Admiralty Leisure Folio
SC5613 Irish Sea - Eastern Part

The Notices to Mariners (NMs) listed below apply to the latest edition of SC5613 (3rd Edition) published on 21st May 2015.

Chart: SC5613·3 ETRS89 DATUM

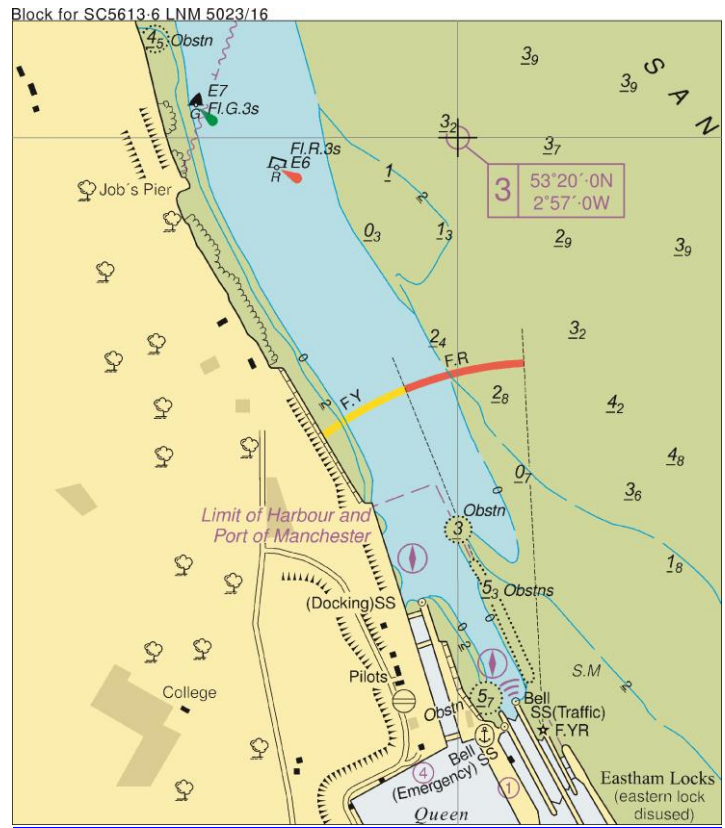
Replace  *Q.G Prestatyn*, with  *Q Prestatyn* 53° 21' ·37N. , 3° 29' ·00W.
